<b>STEPHEN LEVRANT HERITAGE ARCHITECTURE Ltd.</b>  Project : 106 ALBERT STREET, LONDON NW1 7NE Revision: - Date: 01/12/2023 Initial: SH / SK	
---	---	--

Schedule of works

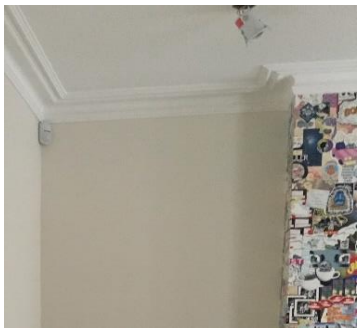
Room / Location	Item	Enforcement issue	Photo / diagram (if required)	Gain Listed Building Consent (LBC) / Remedial Work (RW) / undecided (U)	Proposed Scope and Actions	Reference correspondence /material
EXTERIOR						
External (Front and Rear Elevations)	Repointing to brickwork	The Council have objected to the existing cement pointing as per the original enforcement letter.		RW	Repointing will be carried out with a lime based mortar and should be slightly recessed ensuring the brick is clearly visible.  Outline Method Statement for Repairs - Brickwork (Front and Rear Elevations) included as part of submission.	Agreed during Listed Building Consent Application.
External	Rear Boundary walls	The Council have objected to the existing rear boundary walls which have been covered by a horizontal close-boarded modern fence as per the original enforcement letter.		RW	Timber close-boarded fence on boundary wall to be removed. Existing brickwall to be topped up by a timber lattice/ slat, with reference to methods applied in the immediate surroundings (e.g., below). <b>Detailed design to be conditioned.</b> 	Requested by Council following listed building Consent Application.

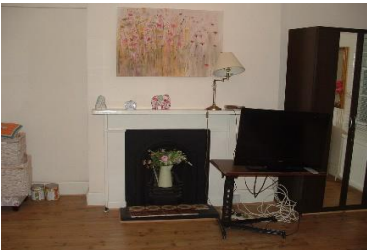
External	Rear Extension	A two storey glazed extension was consented in 2014. The rear extension was built differently from what was approved.		LBC, (proposal accepted retrospectively)	Council confirmed that rear extension is acceptable over email.	Email: From: Kristina Smith Sent: 08 January 2020 10:55 To: Colette Hatton Subject: RE: 106 Albert Street
<b>GROUND FLOOR</b>						
Ground Floor, throughout	Removal of suspended ceilings to principal rooms	The Council have objected to suspended ceilings as per the original enforcement letter.		RW	The client should remove the suspended ceilings <u>as shown on plans</u> as part of the current listed building consent.  Seemingly agreed on latest correspondance as detailed in the 'reference material' column, see right.	Email: From: Kristina Smith Sent: 08 January 2020 10:55 To: Colette Hatton Subject: RE: 106 Albert Street
Ground Floor, front and rear main rooms	Spotlights throughout and wall mounted lights	The Council have objected to unconsented spotlights and wall lights as per the original enforcement letter.		RW	The client should remove the spotlights and wall lights <u>as shown on plans</u> as part of the current listed building consent.  Seemingly agreed on latest correspondance as detailed in the 'reference material' column, see right.	Email: From: Kristina Smith Sent: 08 January 2020 10:55 To: Colette Hatton Subject: RE: 106 Albert Street

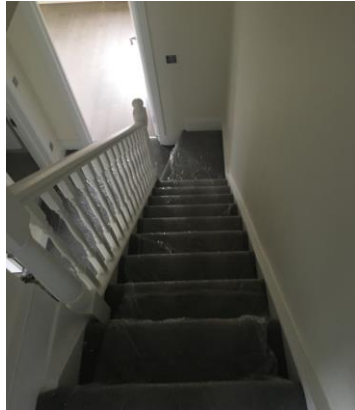
Hallway - Glass balustrade leading to lower ground floor	Glass balustrade / panelling to stairs	The Council have objected to the screen between ground floor and basement as per the original enforcement letter.		LBC (Conditioned)	<p>As per drawings, existing glass screen to be replaced with suitable painted timber panelling in keeping with the historic character of the house. <b>Details to be approved via conditions.</b></p> <p>Seemingly agreed on latest correspondence as detailed in the 'reference material' column, see right.</p>	<p>Email: From: Kristina Smith Sent: 08 January 2020 10:55 To: Colette Hatton Subject: RE: 106 Albert Street</p>
Ground Floor, front room only	Reinstatement of Fireplace to chimneybreast	The Council have objected to the removal of the fireplace(s) at ground floor level as per the original enforcement letter.	<p><b>PRESENT</b></p>  <p><b>FORMER</b> <i>image dated 2013</i></p> 	LBC (Conditioned)	<p>As per drawings, the fireplace in the front room should be replaced to the design of previous photo evidence. <b>Details to be approved via conditions.</b></p> <p>Rear room fire place - no action.</p> <p>Seemingly agreed on latest correspondence as detailed in the 'reference material' column, see right.</p>	<p>Email: From: Kristina Smith Sent: 08 January 2020 10:55 To: Colette Hatton Subject: RE: 106 Albert Street</p>
